Office Action Summary	Application No. 10/563,548	Applicant(s) WON, RAY	
	Examiner IVES WU	Art Unit 1797

DETAILED ACTION

FIG. 3

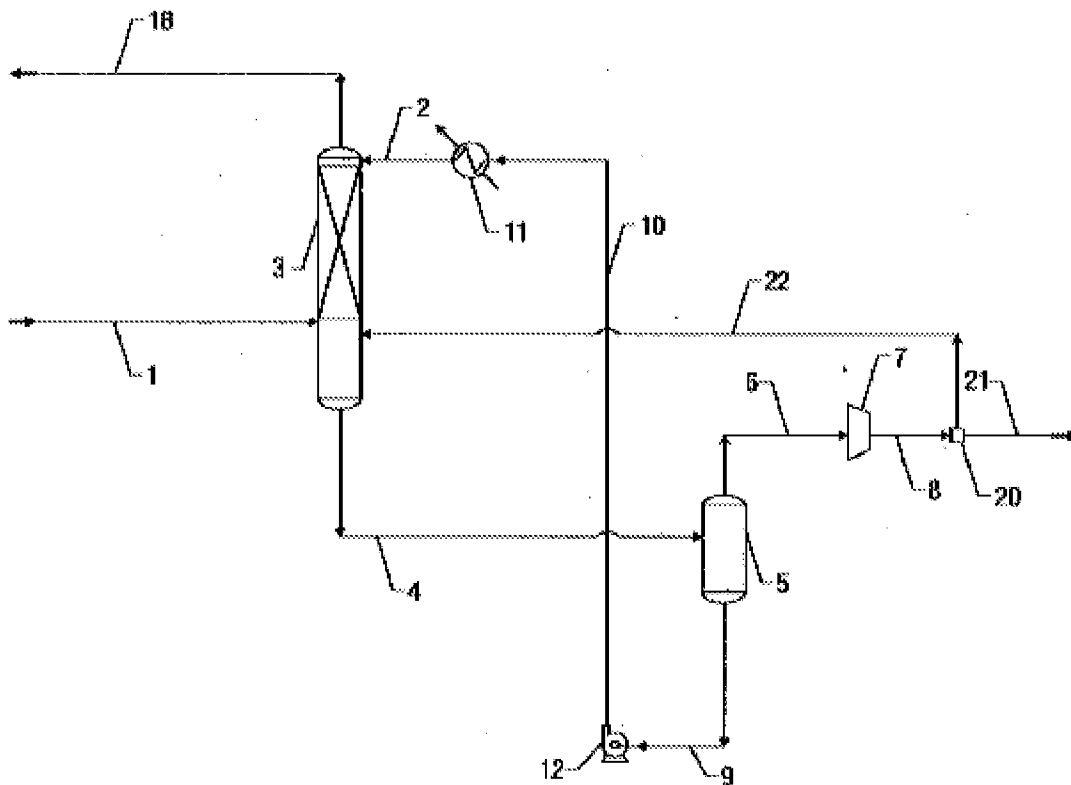
As to a gas treatment plant comprising an absorber in which acid gas is removed from a feed gas using a physical solvent to thereby produce a rich solvent wherein the rich solvent is contact with a recycle gas at a location downstream of an equilibrium stage where the feed gas enters the absorber and wherein the recycle gas is produced from the rich solvent in **independent claim 1**, Gaskin (US 2004003717A1) discloses use of product gas recycle in processing gases containing light components with physical solvents (Title). as shown in the Figure below, it illustrates the extractor 2, lean solvent line 2, recycle gas line 22, feed gas line 1 and rich solvent line 4, flash separator 5. According to the embodiment depicted in Fig. 3, a portion of the product stream 8 is diverted via split 20 and recycled to extractor 3 as stream 22. Stream 22 typically enters the extractor at a point equal to or below the feed stream 1 ([0024], line 17-19).

As to feed gas comprising natural gas at a pressure of at least 2000 psig and wherein the acid gas is at least one of hydrogen sulfide and carbon dioxide in **claim 2**, Gaskin (US 20040003717A1) discloses natural gas ([0022]). The material worked upon does not limit the apparatus claim. MPEP §§ 2155.

As to recycle gas being produced from flashed gases of a plurality of serially coupled flashed vessels wherein the recycle gas is compressed to absorber pressure in **claim 3**, Gaskin (US 20040003717A1) discloses one solution to this contamination having been to subject the enriched solvent to multiple flash stages and to recycle a portion of the gas released from one or more of early flash stages back to the extractor with additional compressors to be included in the process ([0017], line 6-18). It would compress the recycle gas to the pressure of absorber in order to flow into the absorber.

As to rich solvent being contacted with the recycle gas in the bottom portion of the absorber in **claim 6**, Gaskin (US 20040003717A1) discloses stream 22 typically entering the

extractor at a point equal to or below the feed stream 1 ([0024], line 17-19) which includes the bottom of the absorber.

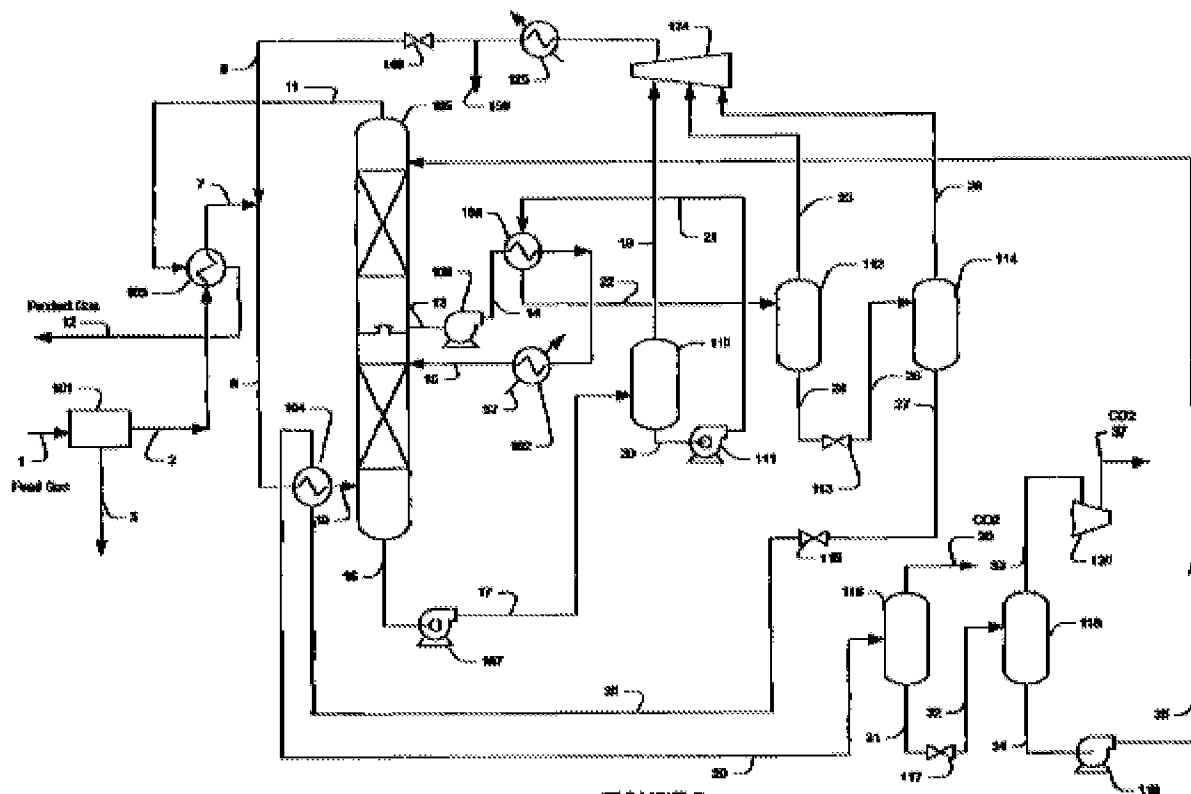
As to a gas treatment plant comprising a contact vessel in which a rich solvent that is formed in an absorber contacts a recycle gas, wherein the recycle gas is produced from the rich solvent, and wherein the absorber receives a feed gas from which an acid gas is removed using a physical solvent, thereby producing the rich solvent in **independent claim 8**, Mak (US 7424808B2) discloses configurations and methods of acid gas removal (Title). As shown in the following Figure 2, it illustrates absorber 105, flash stages 110, 112, 114, separator 116 and vacuum separator 118, rich solvent 16, lean solvent 35. recycle gas 8, feed gas 1, which reads on limitations as claimed.

As to rich solvent being flashed downstream of the contact vessel in a plurality of sequentially coupled flash vessels wherein each of the flash vessels produces a portion of the recycle gas in **claim 11**, as shown in the Figure above, three flash stages 110, 112, 114 and flashed gas 19,23 and 26 which reads on limitations as claimed.

However, Mak (US 7424808B2) **teaches** configurations and methods of acid gas removal (Title). as shown in the Figure 2 of Mak above, the atmospheric separator 116 and vacuum stripper 118 which reads on the limitations as claimed.
